6/6/97 Detail and notes for Type "D" wheelchair

CURB RAMP DETAIL

WAIEHU BEACH ROAD RESURFACING Kahekili Highway to Kahului Beach Road

**ADD. 5S-1**

WHEELCHAIR RAMP - TYPE "D"

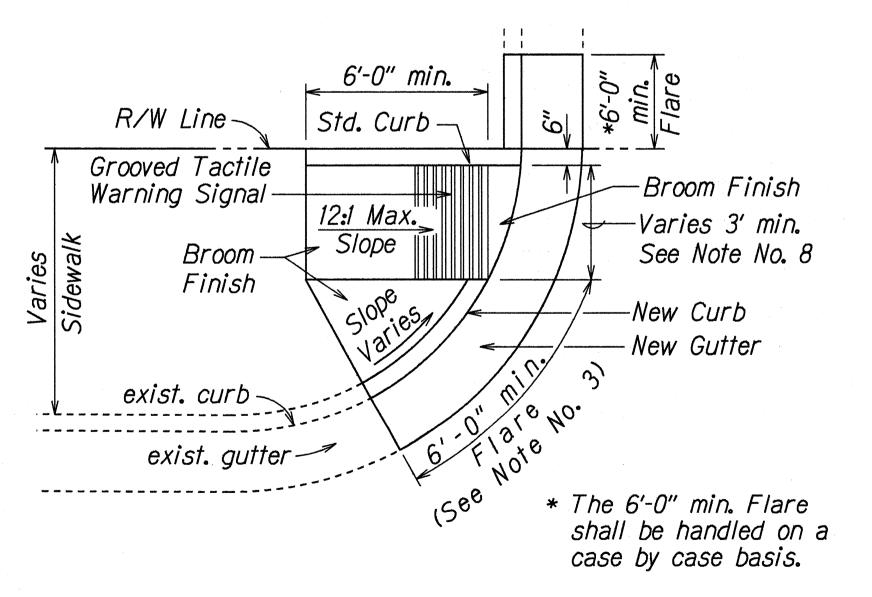
ramp per Addendum No. 2.
